City of Richmond
Planning and Development Department

Report to Committee

RZ 05-317846

Re: Application by ATI Investments Ltd. for Rezoning at 8420 Westminster Highway and 6140, 6160, 6180 Cooney Road from "Townhouse & Apartment District (R3)" to "Comprehensive Development District (CD/202)"

A-3.0

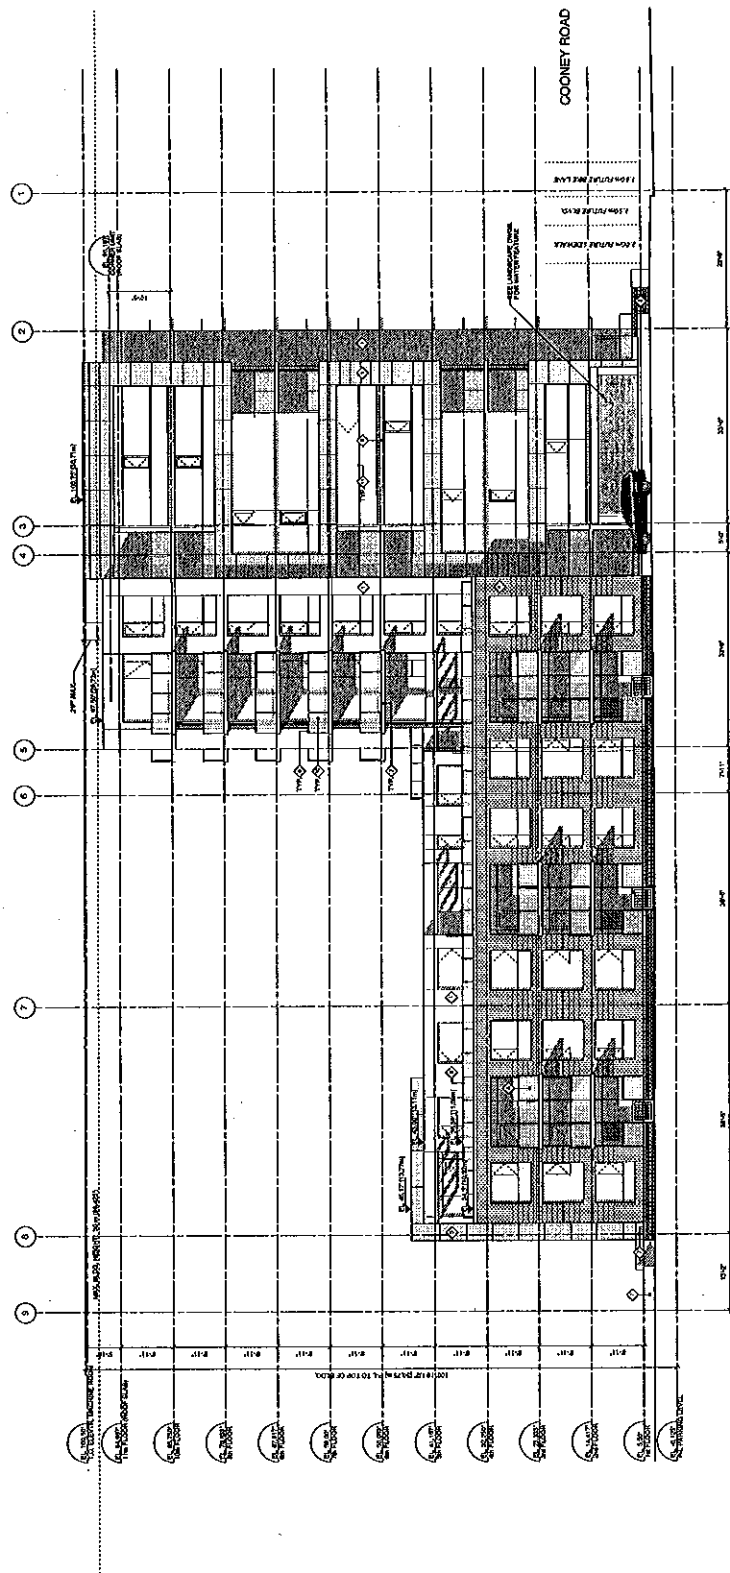
- Design development to the south elevation, especially the portion closer to Cooney Road required to reflect and bring some of the features of the west elevation around the corner, along a portion of the lane. This portion of the building will be exposed to direct views from pedestrians from the street.

WEST
ELEVATION

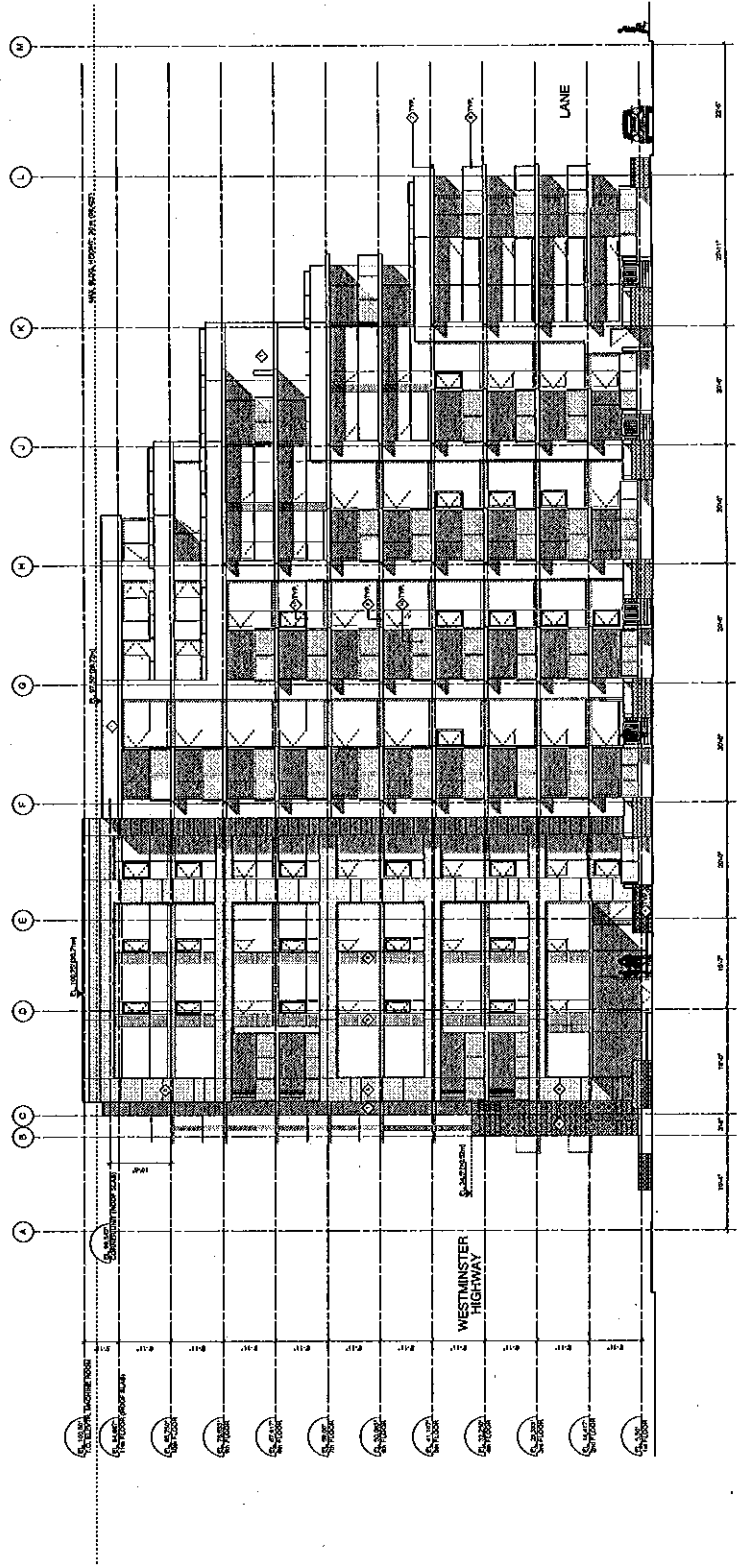
- Design development still required to the west side of the parkade. Consideration to be given to provide cantilevered planters in combination with the proposed fenestrations or development of a "green wall" type of treatment to improve texture and detailing on this side of the parkade that will be exposed to direct views from existing building to the east.
